Access Compliance Report

Public Rights-of-Way

(Curb Ramps)

Intersection ID: 27333	Main Street: BALLANTYNE_MEDICAL_PL	Cross Street: BRIXHAM_HILL_AV	Location: NE
ADA ID: F7526C1620AF	Ramp Type: Perp	Initial Pass/Fail: Fail	Overall Compliance: No
		Severity Score: 12.5

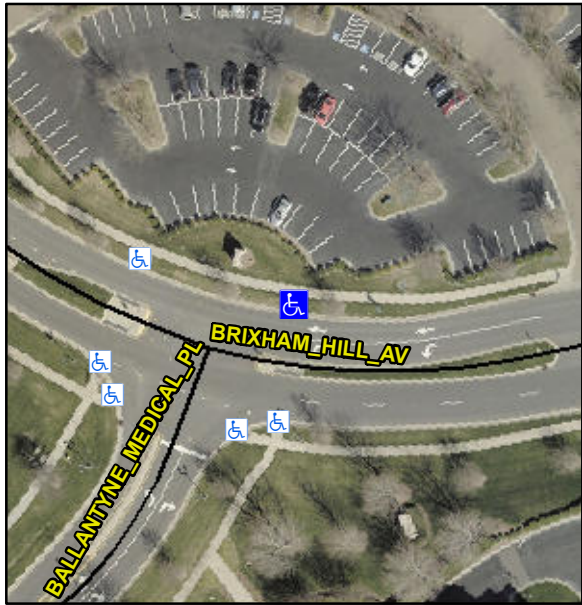
Codes/Mitigation Info/Possible Solution		Field Measurements/Component Compliance						
	Possible Solutions:		Compliance	Description	Data	Compliance	Description	Data
	Remove & Replace Entire Ramp.		N/A	Ramp Length (in)	96.0	No	Ramp Slope (%)	8.6
			Yes	Ramp Width (in)	59.0	Yes	Ramp XSlope (%)	1.7
			N/A	Flare Type LT	N/A	N/A	Flare Type RT	N/A
			N/A	Flare Slope LT (%)	N/A	N/A	Flare Slope RT (%)	N/A
			N/A	Flare Traversable LT?	N/A	N/A	Flare Traversable RT?	N/A
			N/A	Landing Length (in)	N/A	N/A	DWS Provided?	N/A
			N/A	Landing Width (in)	N/A	N/A	DWS Contrast?	N/A
			N/A	Landing Slope (%)	N/A	N/A	DWS Length (in)	N/A
			N/A	Landing X Slope (%)	N/A	N/A	DWS Full Width?	N/A
Surveyor Notes:		N/A	N/A	Landing Curb? (Y/N)	N/A	N/A	DWS Offset (in)	N/A
PROW/ADA:		Not Found, R304.2.2	N/A	Shared Landing?	N/A			
			N/A	Gutter Ponding?	N/A	N/A	Gutter Slope (%)	N/A
			N/A	Gutter Lip Ht (in)	N/A	N/A	Gutter X Slope (%)	N/A
